Appendix E

Responses to Comments on the Draft IS-MND

This section includes comments received during the circulation of the Draft Initial Study and Mitigated Negative Declaration (IS-MND) for the Medea Creek Restoration Project (SCH# 2015011008) and responses to those comments.

3 STAIRS - RAILING DETAIL
NTS

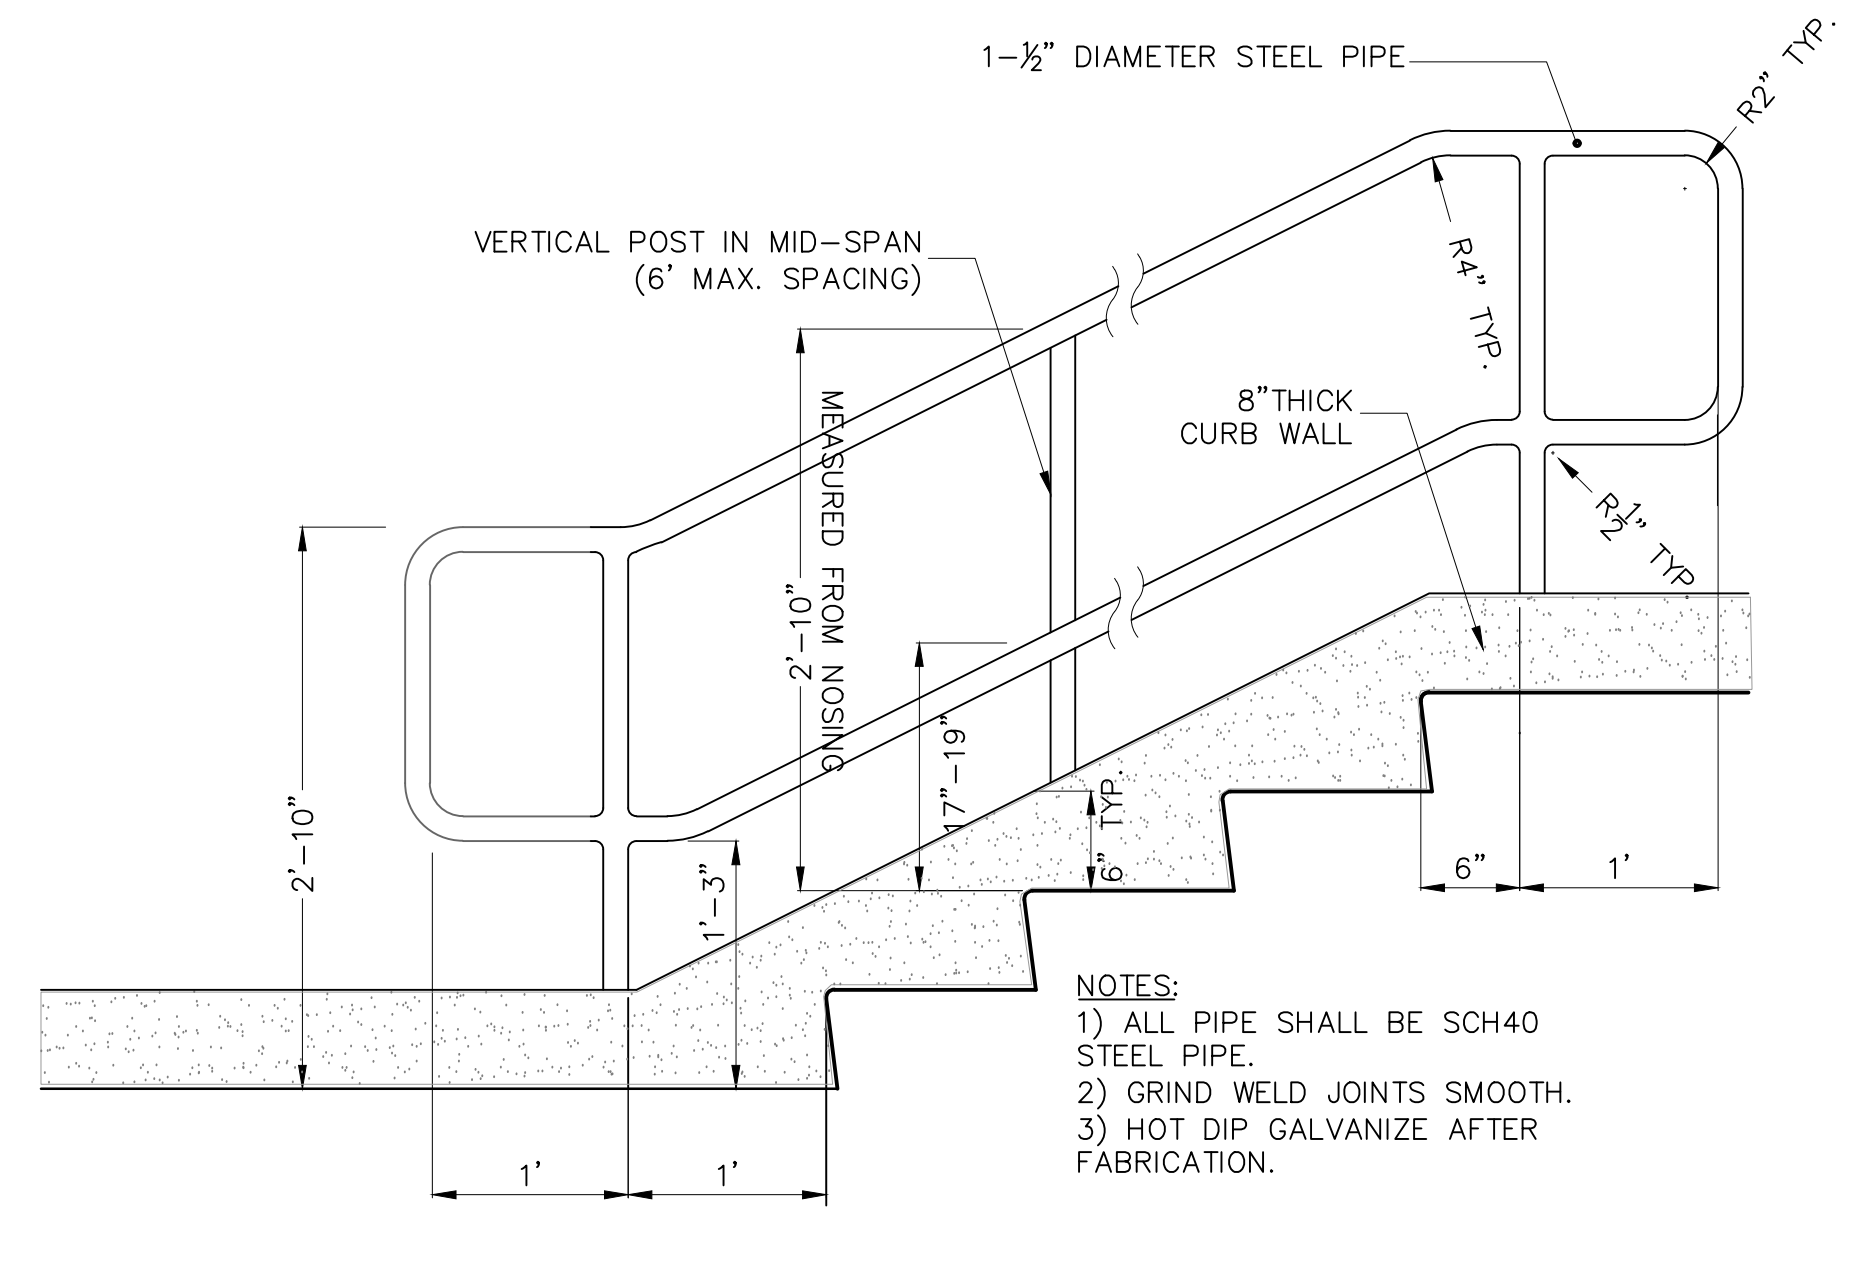
- 1) Add ramp alongside the stairway to Kanan. This ramp would be for bicyclists and the handicapped.
- 2) Along the northern side of the Annandale condos add a trail to intersect with the trail that already goes around the Chumash ball-field. This northern side is the least steep side with a gentle slope. This enables Annandale II condos to have easy access to this Media Creek Restoration Project.

- 1) Add ramp alongside the stairway to Kanan Road for bicyclists and handicapped users.
- 2) Along the northern side of the Annandale condos add a trail to intersect with the trail that currently is located around the edge of the Chumash ball-field.

The commenter's support for the proposed project is noted. Note that the slope on the eastern side of the project site where the stairs would connect the pedestrian pathway to Kanan Road precludes provision of an ADA-compliant ramp. However, an ADA compliant trail is provided as part of the proposed project and could also be used by cyclists. The proposed 12-foot wide ADA compliant trail on the west side of the channel would connect Kanan Road to Chumash Park via a pedestrian bridge. See Sheet 9 of the preliminary construction drawings included in Appendix D for further detail.
